Planning Committee – 14 April 2011

Addendum

Page 29, 10/3738/FUL, 68 Gloucester Road Hampton

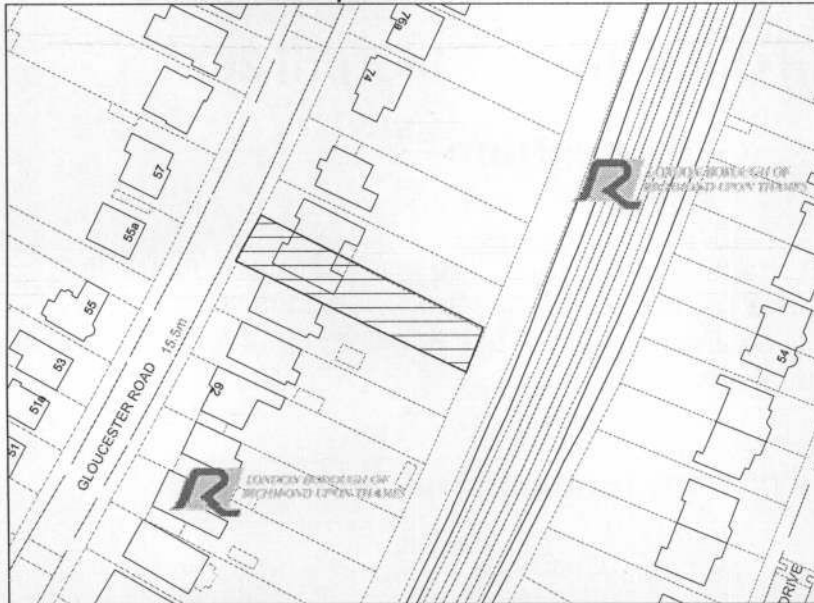
- Correct location plan
